RE: Flat Country Draft EIS Comments

Please consider the following comments, submitted on behalf of Cascadia Wildlands and Oregon Wild, regarding the Draft EIS for the Flat Country Project. Cascadia Wildlands is a public interest nonprofit organization with 10,000 members and supporters throughout the Cascadia bioregion. Our mission is to defend and restore Cascadia's wild ecosystems in the forests, in the courts, and in the streets. We envision vast old-growth forests, rivers full of wild salmon, wolves howling in the backcountry, and vibrant communities sustained by the unique landscapes of the Cascadia bioregion.

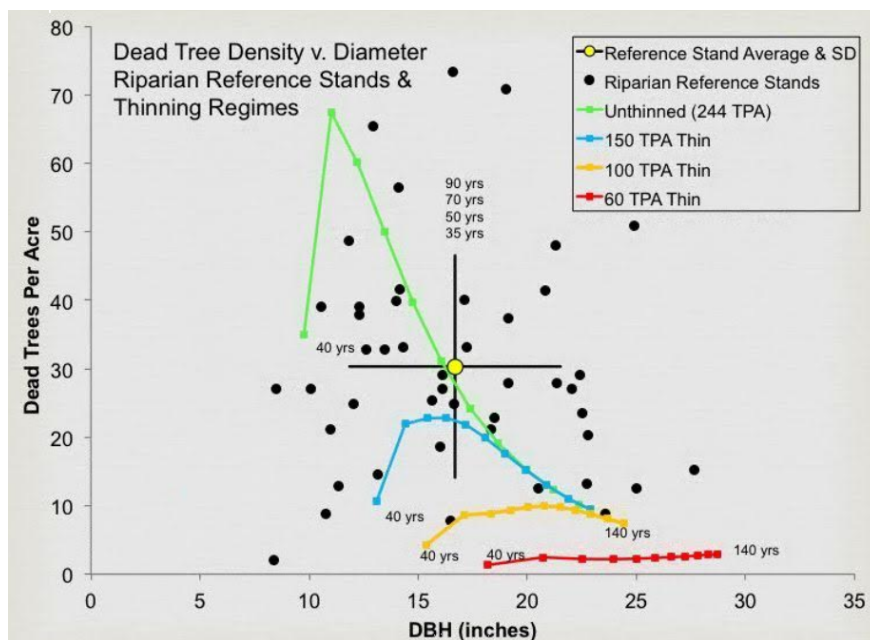
Tables 36 and 37 are clear, and show a general lack of snags but healthy amount of large down wood in Flat Country units. That, generally speaking, fits with our observations, and makes sense for mature stands like these, that are just now starting to transition to old-growth (Image at left, Unit 1970)

How significant a factor is fire in creating snags, as compared with other factors such as disease, competition mortality, wind and snow? We commonly noticed blowdown and snapped-tops in units. Natural openings are being created. On a variable landscape like this, with variable fire regimes, there could be differences. Western hemlock groves for example operate very differently than lodgepole pine. The DEIS pretends as though fire were the only factor, which is absurd.
